**DEVIATION REQUEST
AND DECISION FORM**

Project Name : Falcon Meadows at Bent Grass Filing No. 4
 Schedule No.(s) : 5301201061, 5301201062, 5301201063, 5301301054
 Legal Description : Falcon Meadows at Bent Grass Filing No. 4

A deviation from the standards of or in Section **2.3.2, Table 2-7** of the Engineering Criteria Manual (ECM) is requested.

LEMON GRASS DR. (LEMON GRASS ROAD (STREET L)) STA: -0+40 - 6+40
SCALE: H: 1"=30' V: 1"=3'

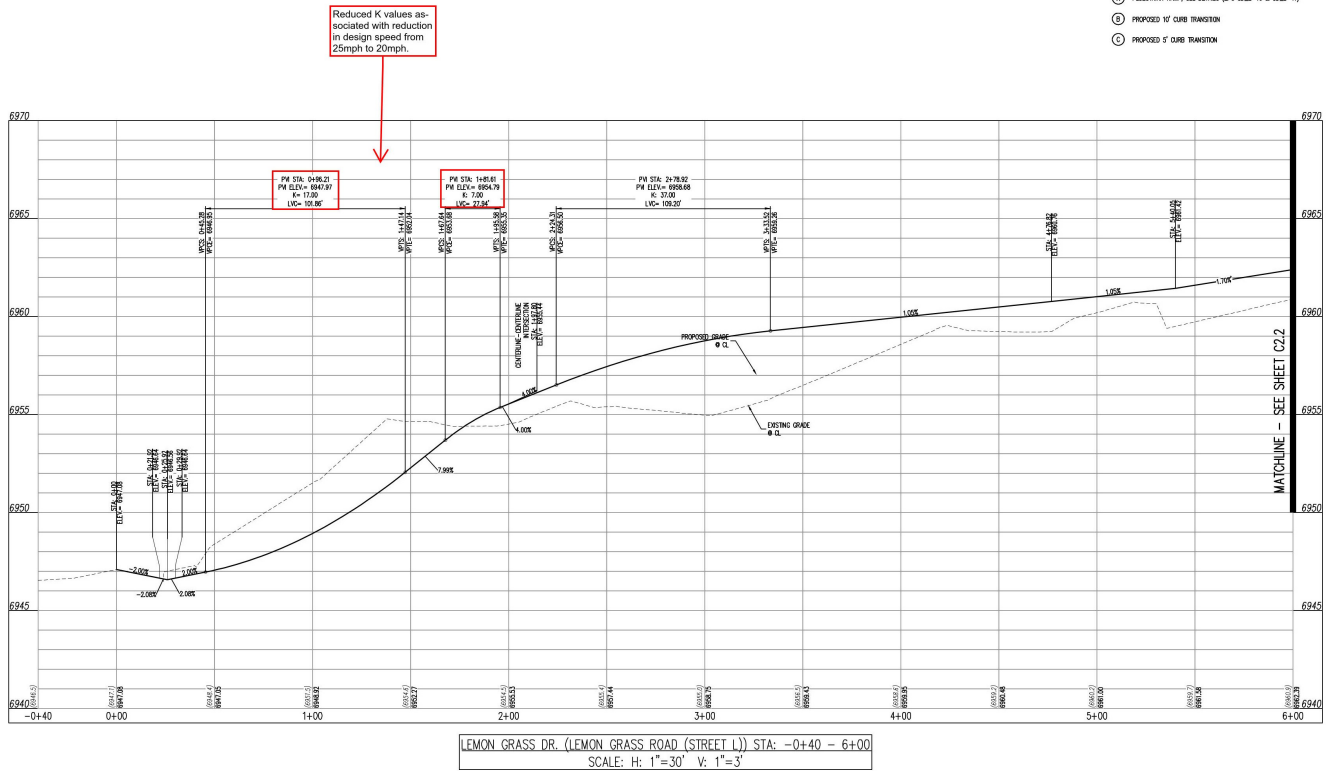
We are requesting a deviation to the ECM Section 2.3.2, Table 2-7, Design Speed/Posted Speed for a local road due to not being able to meet the K values at the typical 25 mph speed limit. We are proposing a reduced speed of 20 mph in this section of Lemon Grass Dr. to meet the reduced K values of 7 for the crest curve and 17 for the sag curve. Furthermore, this deviation is required due to the three roads (Silty Thread Rd., Willmore Dr., and Bent Grass Meadows Dr.) connecting to Lemon Grass Dr. already being constructed with homes currently in place on the lots. Due to the roads already being fully constructed with homes in place, it is not feasible to alter the design elevation of these roads to meet the K values associated with the typical 25 mph speed limit for Lemon Grass Dr. Therefore we are requesting to deviate to a 20 mph speed limit in this section of Lemon Grass Dr. A plan and profile for Lemon Grass Dr. has been provided below to highlight the area in which the deviation is requested.

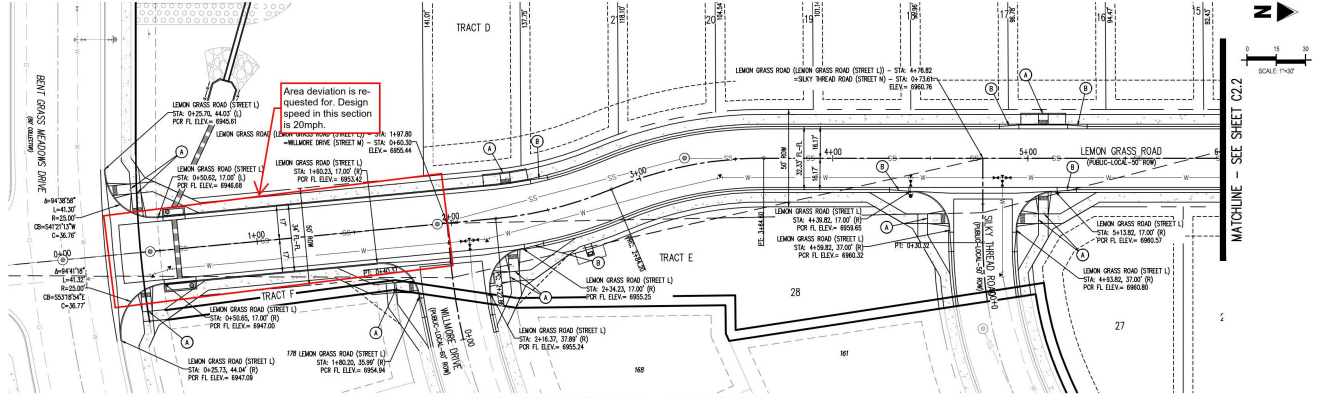
The proposed alternative is to design the road to meet the required K values associated with a 20 mph speed limit which are 7 for a crest vertical curve, and 17 for a sag vertical curve. This will cause a reduction in the ECM speed limit criteria for a local road, which is 25 mph and a reduction in the associated K values of 12 for a crest vertical curve (per ECM Section 2.3.2, Table 2-12) and a K value of 26 for a sag vertical curve (per ECM Section 2.3.2, Table 2-14).

Compared to the ECM typical criteria for a local road, we are reducing the speed limit by 5mph, and reducing the K value in our crest vertical curve by 5 and 9 in the sag vertical curve.

Reduced K values associated with reduction in design speed from 25mph to 20mph.

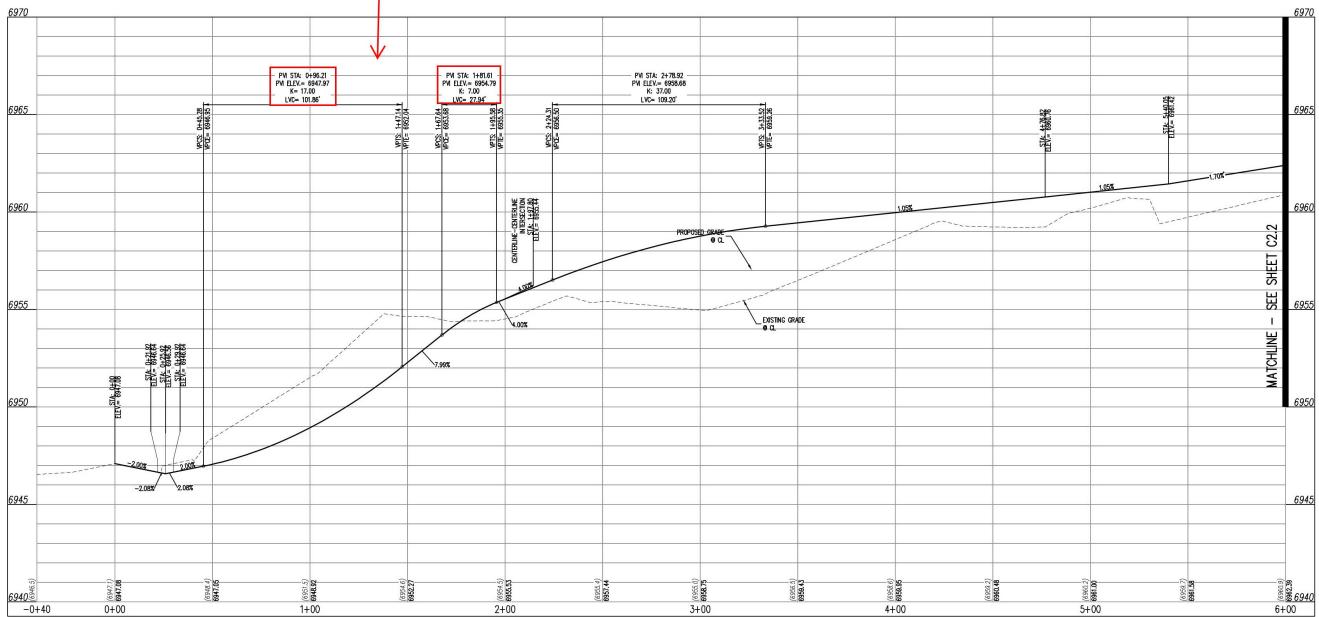
Due to the existing roads that Lemon Grass Rd. is tying into (Bent Grass Meadows Dr., Willmore Dr., and Silky Thread Rd.), we cannot meet the K values required by the ECM for a design speed of 25 mph due to horizontal and vertical constraints, while maintaining compliance to ADA standards. Attached below is a plan and profile view of the area in which we are constrained and requesting deviation to a reduced speed limit of 20 mph and associated K values. Per Jeff Rice with El Paso County email dated 09/01/2023, the reduced speed limit (20 mph) and K values (7 and 17) would be an appropriate alternative to meet design intent and requirements for vertical curves in this road section.

This request has been determined to have met the criteria for approval. A deviation from Section 2.3.4 – 2.3.4 of the ECM is hereby granted based on the justification provided.
